ALERT SERVICE BULLETIN
REVISION NOTICE

**SUBJECT: REVISION "A" TO ALERT SERVICE BULLETIN 412-09-136:
TAIL ROTOR BLADE P/N 212-010-750-ALL, INSPECTION OF.**

NO. 412-09-136
DATE Nov 09, 2009
PAGE 1 of 5

DATE	12-08-09
REV	A

Figure 1

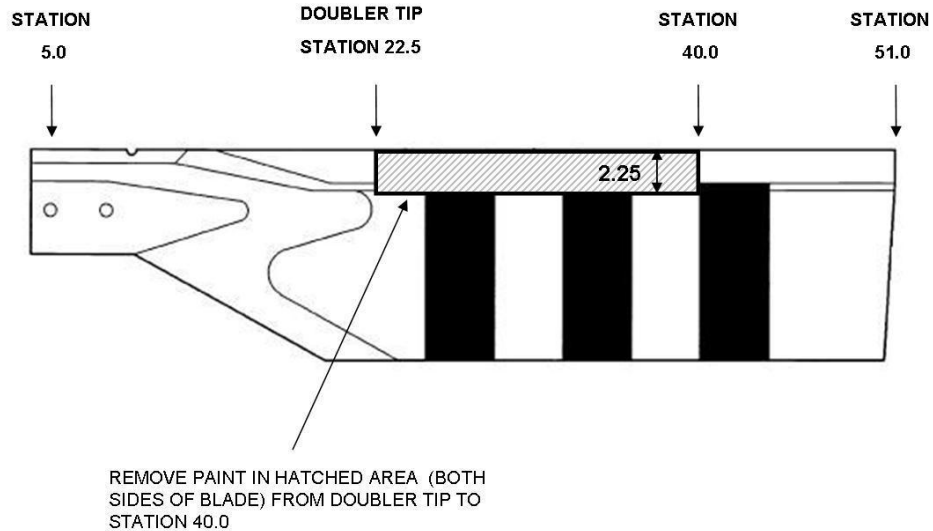
4. Ensure that all paint (on the spar only) is removed from the first 2.25 inches of the leading edge (chordwise) and from the B.S 22.5 (doubler tip) to B.S. 40.0. Refer to Figure 1. This will expose the spar up to the fillet between the blade spar and skin. A fillet filled with adhesive runs spanwise between the blade spar and the skin 2.25 inches aft of the blade leading edge, both inboard and outboard sides. The area to be inspected runs along the edge of the spar fillet and a half inch forward of this point. (Between 1.75 and 2.25 inch from the leading edge of the blade and from Blade Stations 22.5 to 40.0, both inboard and outboard sides).

5. Wipe area with a clean cloth dampened with alcohol (C-385) or aliphatic naphtha (C-305) and dry thoroughly.
6. Carry out a detailed visual inspection of the spar for corrosion and/or pitting using a 3-power or higher magnifying glass. Anomalies on the steel spar 0.003 inch deep or less must be polished out in accordance with BHT-412-MM.

Any defect greater than 0.003 inch deep is cause for rejection and the blade must be removed from service.
